Title - Sujet CD Howe Aménagement/Refit	
Solicitation No. - N° de l'invitation EP067-151357/A	Amendment No. - N° modif. 003
Client Reference No. - N° de référence du client 20151357	Date 2015-01-22
GETS Reference No. - N° de référence de SEAG PW-\$\$\$FG-340-66468	
File No. - N° de dossier fg340.EP067-151357	CCC No./N° CCC - FMS No./N° VME
Solicitation Closes - L'invitation prend fin at - à 02:00 PM on - le 2015-02-03	Time Zone Fuseau horaire Eastern Standard Time EST
F.O.B. - F.A.B. Plant-Usine: <input type="checkbox"/> Destination: <input checked="" type="checkbox"/> Other-Autre: <input type="checkbox"/>	
Address Enquiries to: - Adresser toutes questions à: Brouillet, Richard	Buyer Id - Id de l'acheteur fg340
Telephone No. - N° de téléphone (819) 956-0457 ()	FAX No. - N° de FAX (819) 956-8335
Destination - of Goods, Services, and Construction: Destination - des biens, services et construction: Édifice CD Howe/ CD Howe Building 235 rue Queen Street Ottawa, ON K1A 0H5

AMENDMENT 3 IS RAISED TO ATTACH ADDENDUM 2 AND 3

Project Number: R.064703.002

C.D. HOWE BUILDING, OTTAWA, ON
1W FIT UP AND M&E UPGRADE

DETAIL - 2/A111
(PARTIAL &
REVISED)

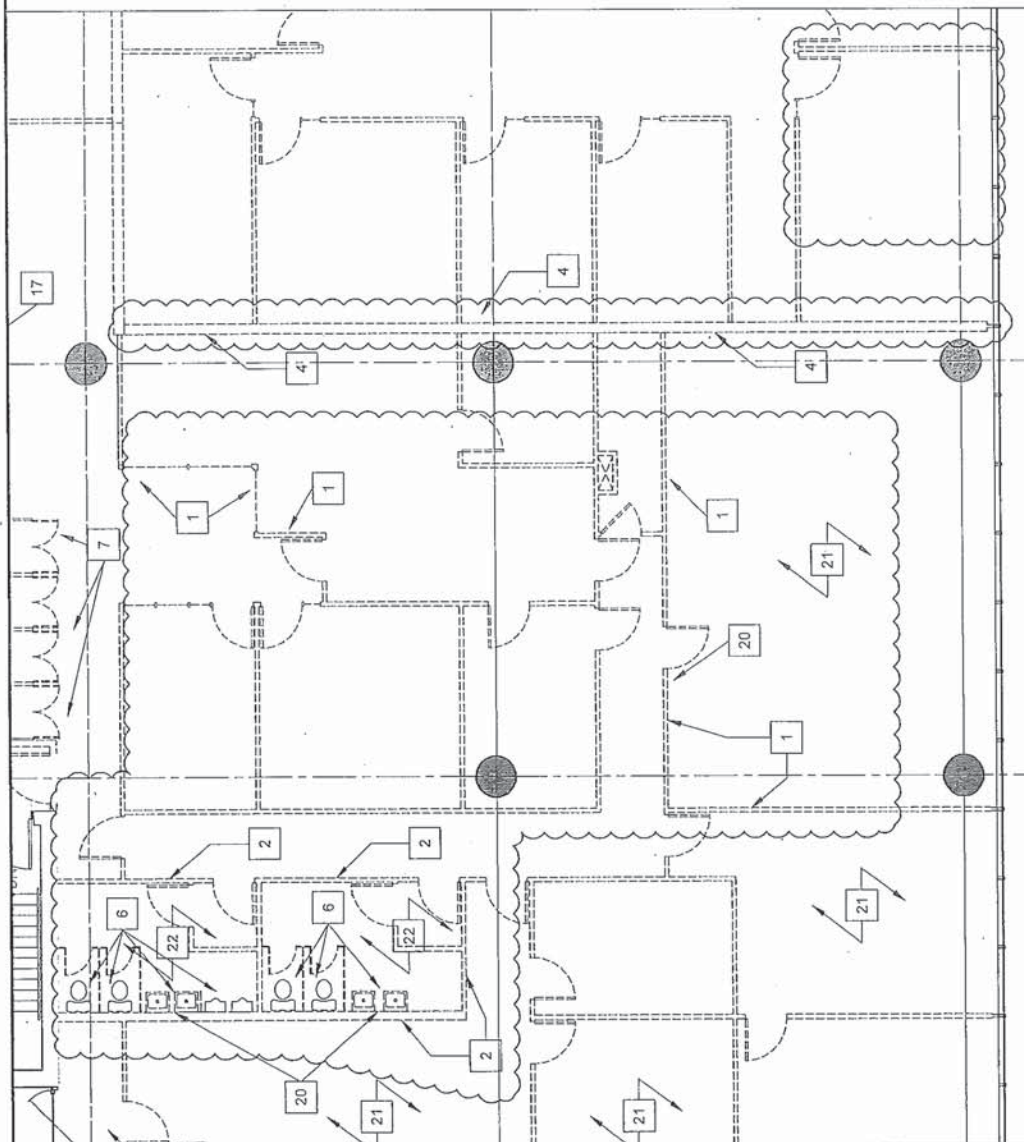
.4 Refer to Detail **2/A111** (specifically the revision cloud between grids E2 and G4), sketch ADD2-SK2 (attached):

ADD notes 1 & 2, as shown in sketch ADD2-SK2.

.5 Refer to Detail **2/A111** (specifically the revision cloud to the right of grid 4 between grids E and G), sketch ADD2-SK2 (attached):

DELETE existing partition to remain, **REPLACE** with existing partition to be demolished.

ADD note 4, as shown in sketch ADD2-SK2.

.6 Refer to Detail **2/A111** (specifically the revision cloud between grids 4 and 5), sketch ADD2-SK2 (attached):

NOTE change in configuration of partitions to be demolished

1. REMOVE EXISTING PLENUM BARRIER ABOVE CEILING GRID. (GYPSUM BOARD/STUDS/GYPSUM BOARD).
2. REMOVE EXISTING SLAB TO US CEILING GRID PARTITION. (GYPSUM BOARD/STUDS/GYPSUM BOARD) INCLUDING FLOOR BASE WALL, MOUNTED ACCESSORIES, DOORS, FRAMES, & SIDELIGHTS.
3. REMOVE EXISTING SLAB TO SLAB PARTITION. (METAL MESH GYPSUM BOARD/STUDS/BATT INSULATION/GYPSUM BOARD) INCLUDING DOORS, FRAMES, & SIDELIGHTS.

3
 A111
 1 WEST DEMOLITION PLAN
 (PARTIAL)
 SCALE 1:100

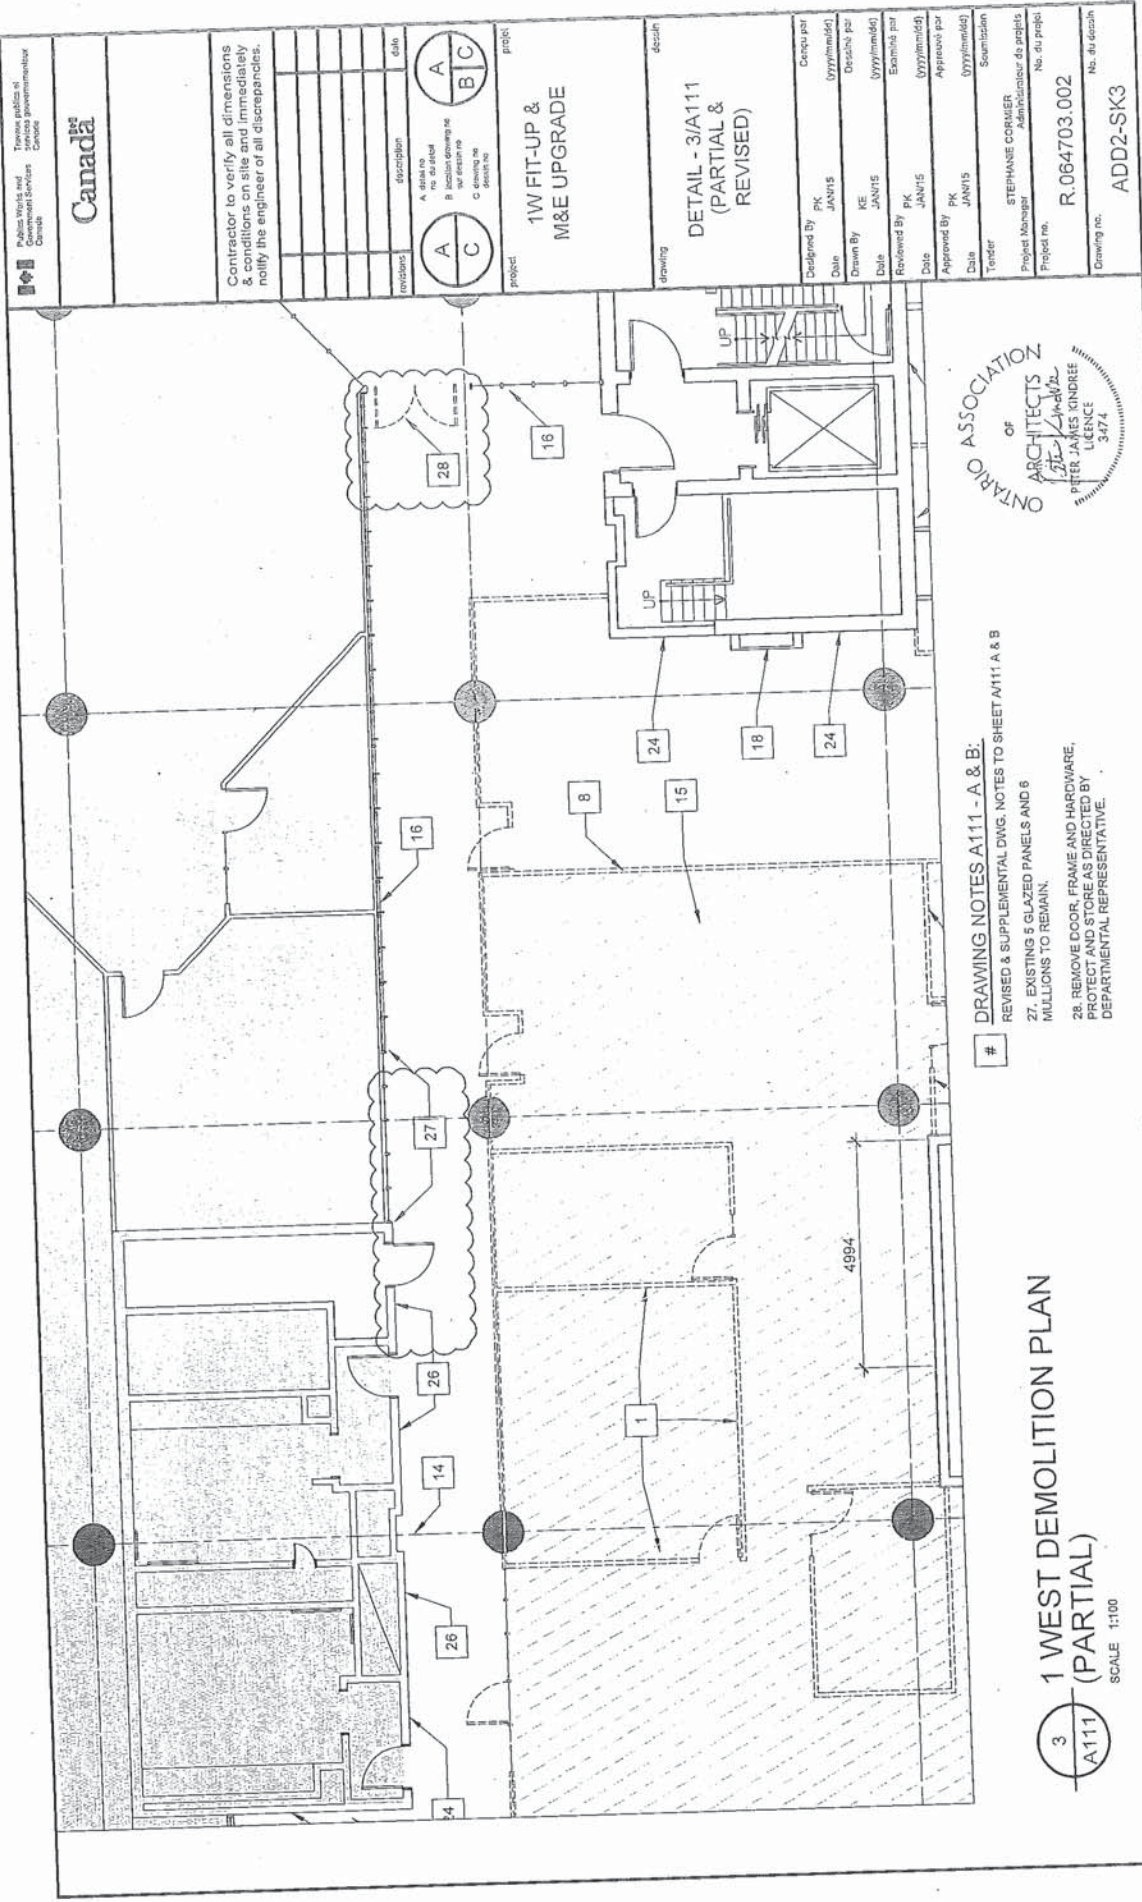
.7 Refer to Detail **3/A111** (specifically the revision cloud above grid E between grids 9 and 10), sketch ADD2-SK3 (attached):

ADD note 27, as shown in sketch ADD2-SK3.

- .8 Refer to Detail **3/A111** (specifically the revision cloud to the right of grid 10), sketch ADD2-SK3 (attached):
NOTE: door to be removed,
ADD note 28, as shown in sketch ADD2-SK3.

DRAWING NOTES A111 - A & B:
 REVISED & SUPPLEMENTAL DWG. NOTES TO SHEET A111 A & B
 27. EXISTING 5 GLAZED PANELS AND 6 MULLIONS TO REMAIN.
 28. REMOVE DOOR, FRAME AND HARDWARE, PROTECT AND STORE AS DIRECTED BY DEPARTMENTAL REPRESENTATIVE.

DETAIL - 1/A121
(PARTIAL &
REVISED)

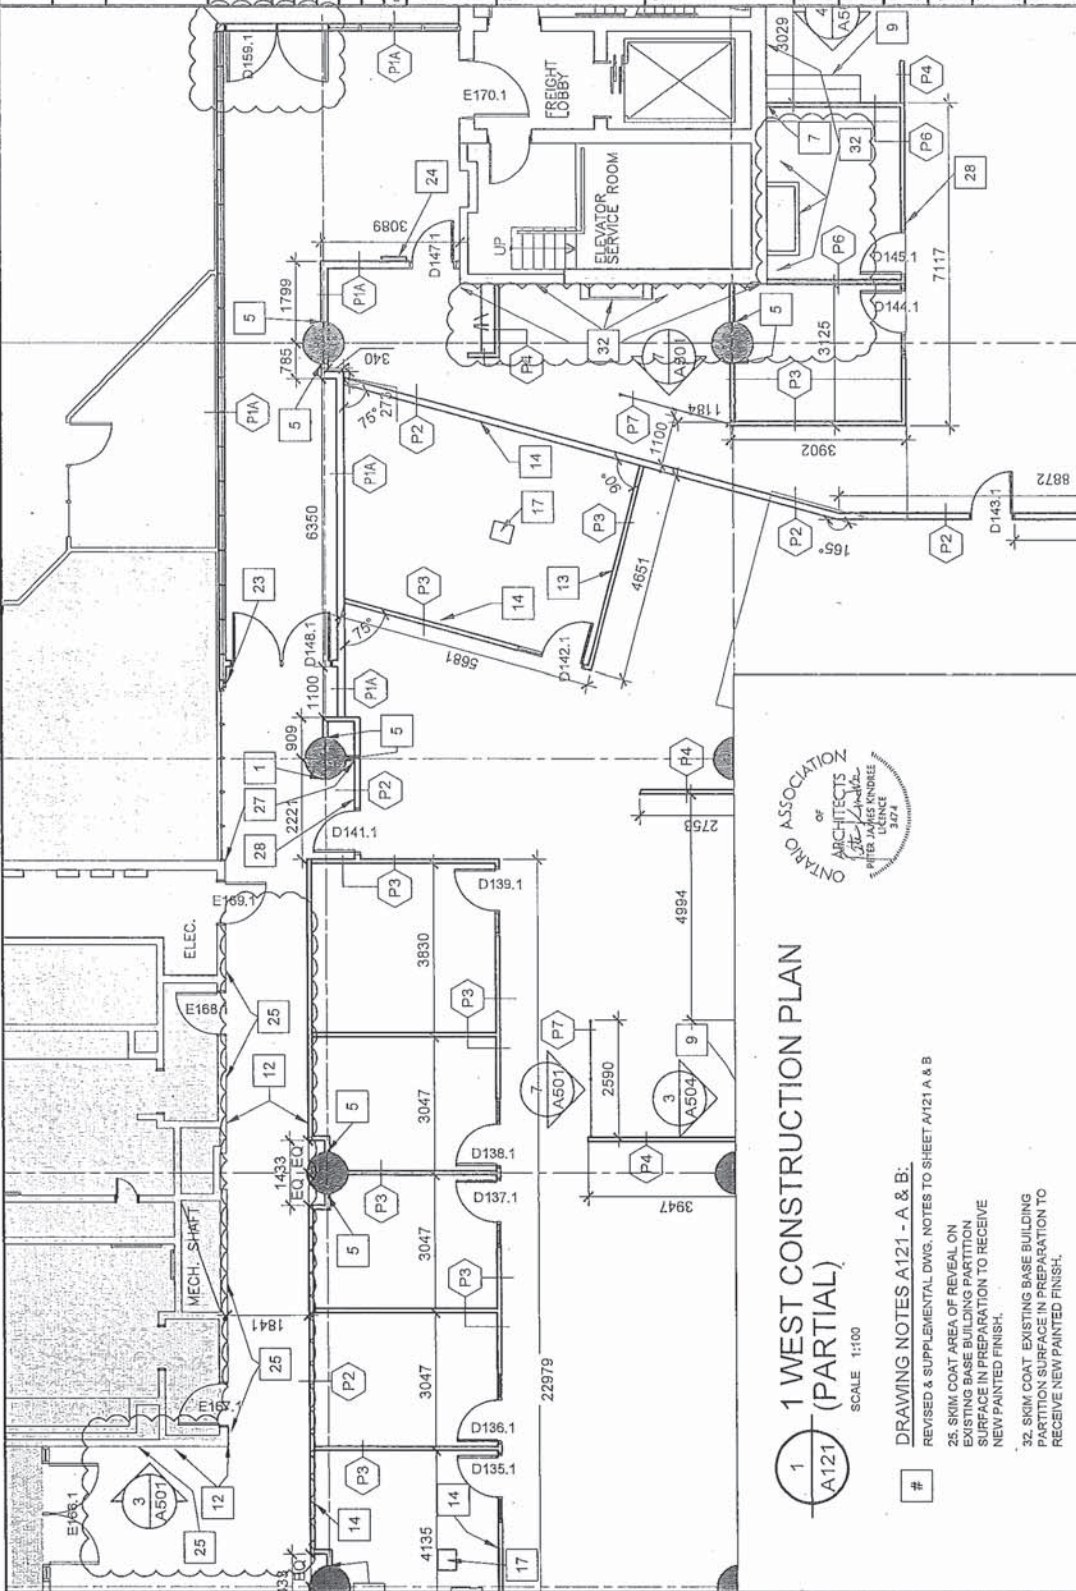
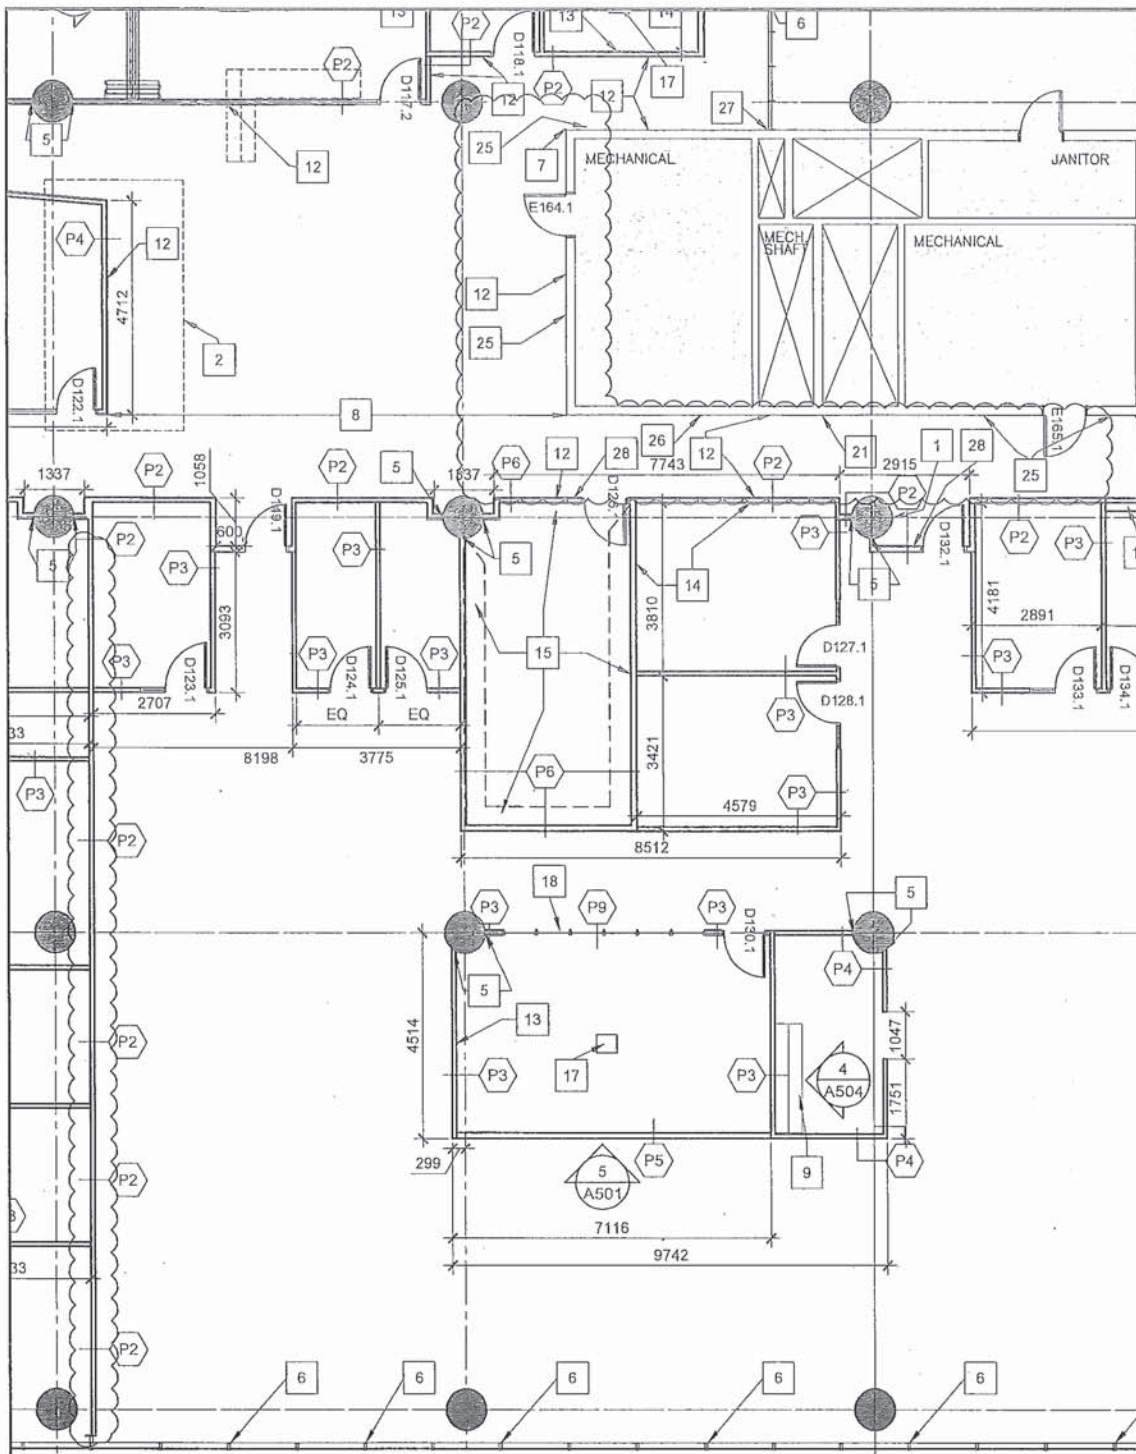
- .2 Refer to Detail **1/A121** (specifically the revision cloud above grid E), sketch ADD2-SK4 (attached):
ADD note 25, as shown in sketch ADD2-SK4.
- .3 Refer to Detail **1/A121** (specifically the revision cloud to the right of grid 10), sketch ADD2-SK4 (attached):
ADD note 32, as shown in sketch ADD2-SK4.

25. SKIM COAT AREA OF REVEAL ON EXISTING BASE BUILDING PARTITION SURFACE IN PREPARATION TO RECEIVE NEW PAINTED FINISH.

32. SKIM COAT EXISTING BASE BUILDING PARTITION SURFACE IN PREPARATION TO RECEIVE NEW PAINTED FINISH.

2 **1 WEST CONSTRUCTION**
A121 PLAN (PARTIAL)
SCALE 1:100

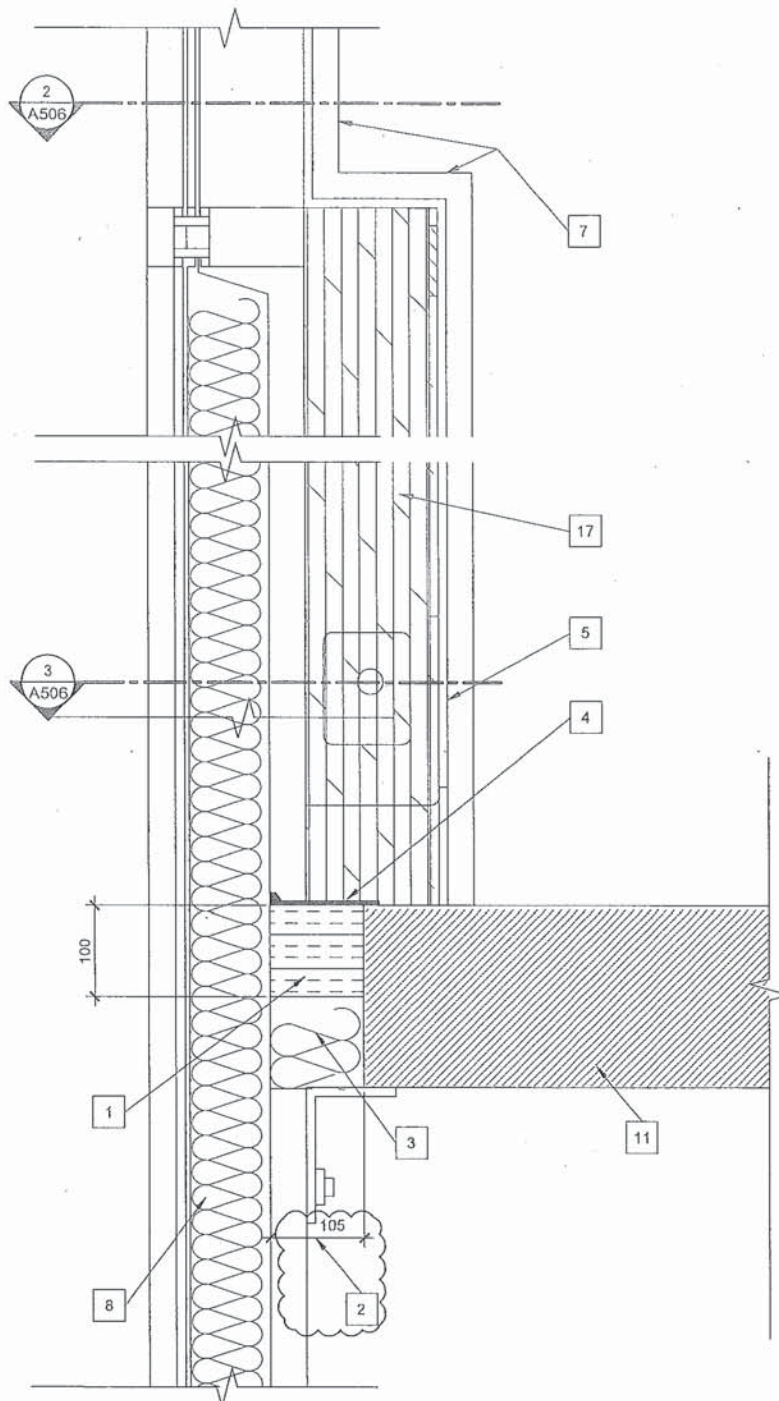
- .4 Refer to Detail **2/A121** (specifically the revision cloud above grid E), sketch ADD2-SK5 (attached):
ADD notes 25 & 26, as shown in sketch ADD2-SK5.

- .5 Refer to Detail **2/A121** (specifically the revision cloud to the right of grid 4), sketch ADD2-SK5 (attached):
ADD partition indicator P2, note new partition to be constructed, as shown in sketch ADD2-SK5.

- .6 Refer to Detail **2/A121** (specifically the revision cloud to the right of grid 10), sketch ADD2-SK5 (attached):
ADD door D159.1 as shown in sketch ADD2-SK5.

DRAWING NOTES A121 - A & B:
REVISED & SUPPLEMENTAL DWG. NOTES TO SHEET A/121 A & B
25. SKIM COAT AREA OF REVEAL ON EXISTING BASE BUILDING PARTITION SURFACE IN PREPARATION TO RECEIVE NEW PAINTED FINISH.
26. FILL HOLES LEFT FROM WALL SPEAKER REMOVAL, MAKE READY FOR ADDITIONAL LAYER OF GYPSUM WALL BOARD
